V5_Civil CDs_comments.pdf Markup Summary

CARUBIA PROPERTIES - GRADING AND EROSION CONTROL SITE DEVELOPMENT CONSTRUCTION PLANS

LOT 2, BENT GRASS EAST COMMERCIAL FILING NO. 4

PPR256

GRADING PLAN
CARUBIA PROPERTIES
LOT 2, BENT GRASS EAST COMMERCIAL FILING NO. 4
8059 MERIDIAN PARK DR
COUNTY OF EL PASO, COLORADO

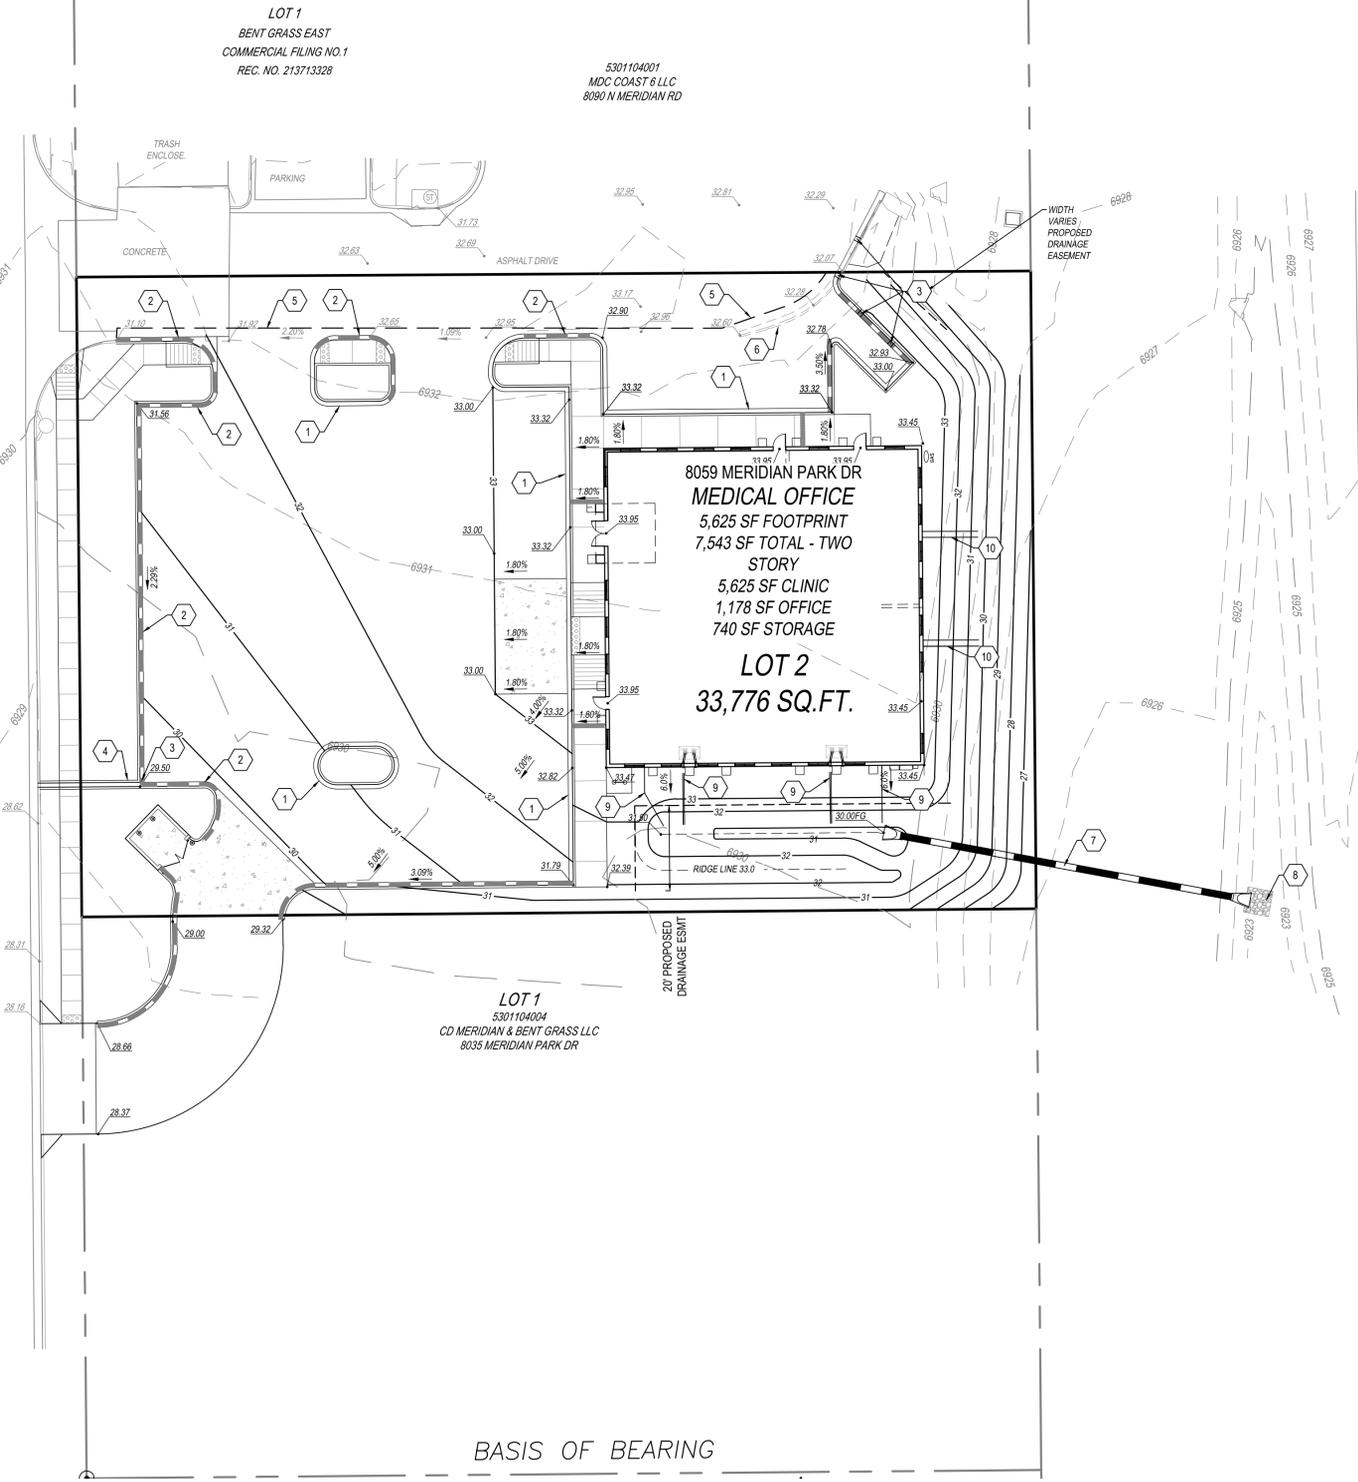
Revise notes as needed per my comments in the MHFD calcs in the Drainage Letter.

Notes revised per Drainage Letter comments on grading plan and utility plan.

SHEET
C5.11

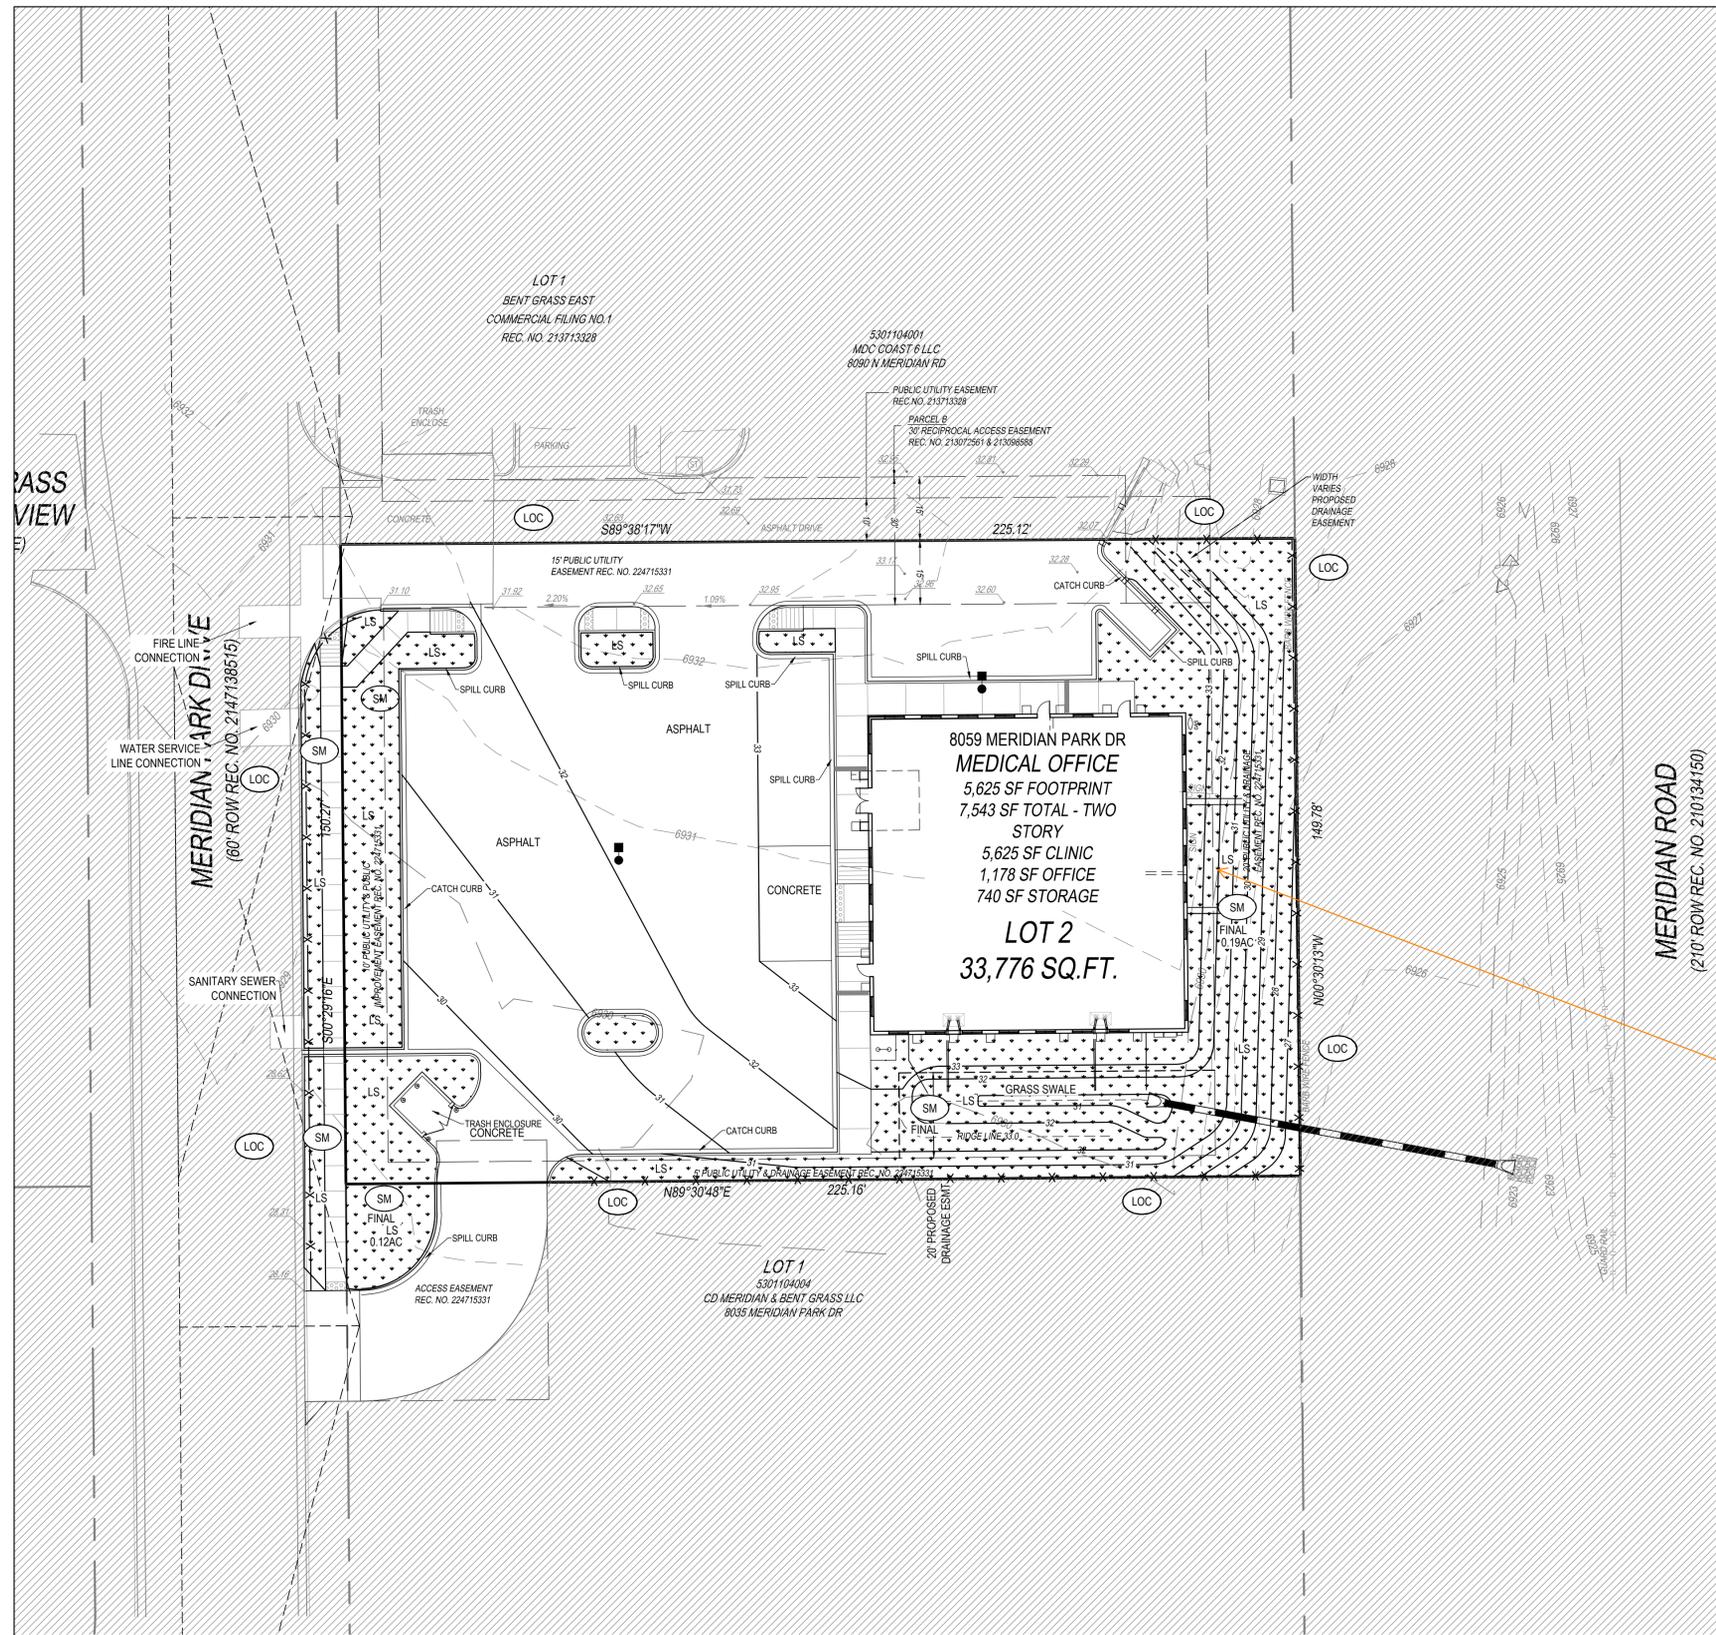
Per the blue shading on the next sheet, some of this area shown with SM hatching is actually rock. Please revise SM hatching and label/hatch as rock to account for this.

SM revised and rock shown on plans.

UTILITY PLAN
CARUBIA PROPERTIES
LOT 2, BENT GRASS EAST COMMERCIAL FILING NO. 4
8059 MERIDIAN PARK DR
COUNTY OF EL PASO, COLORADO

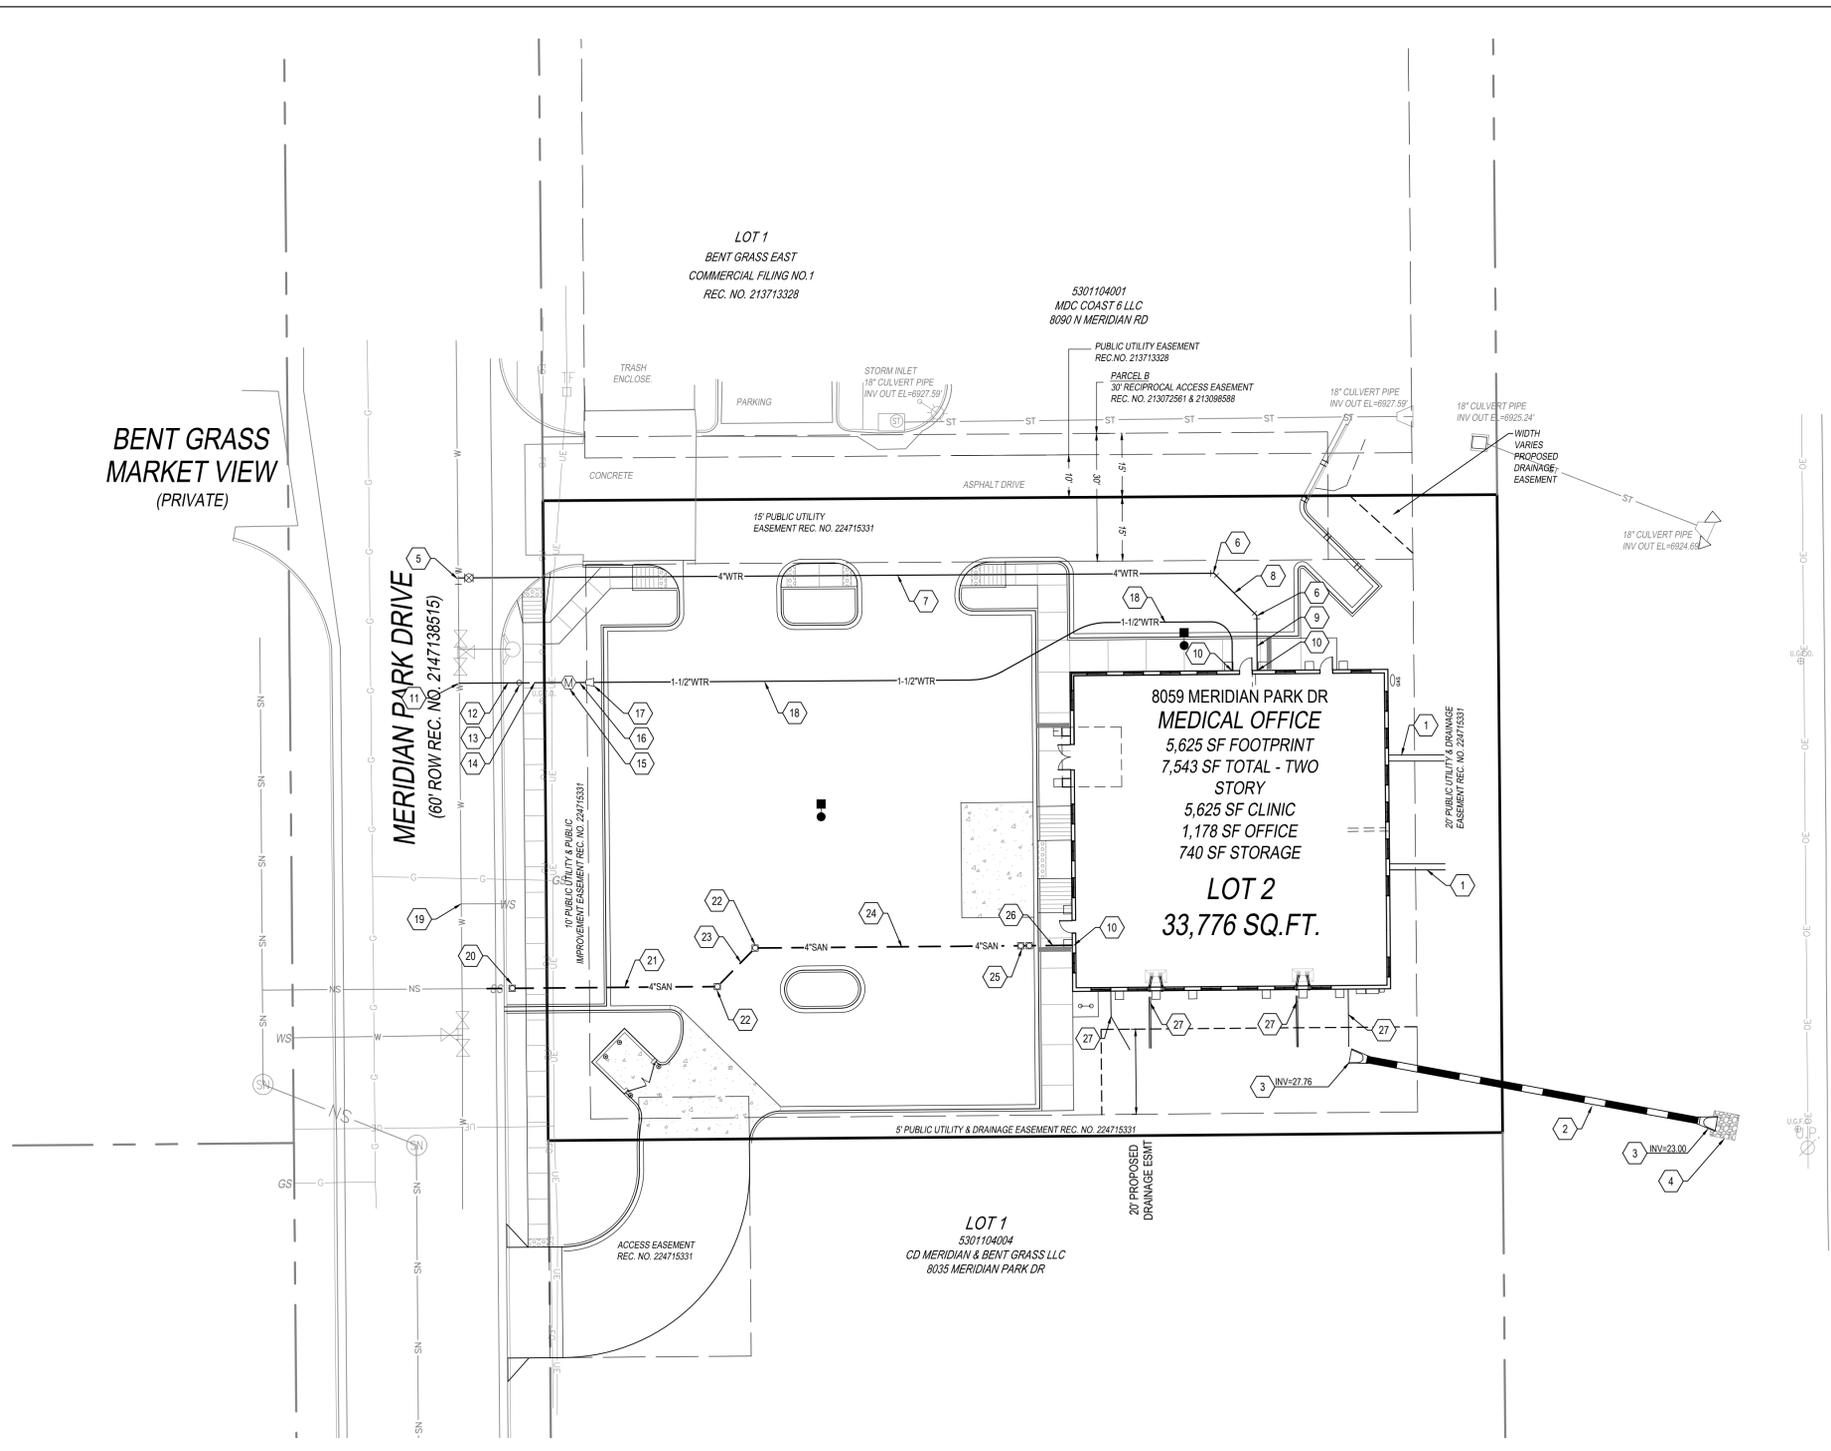
Still unresolved comment from previous two reviews: specify depth of riprap too

2' deep has been added to note 4.
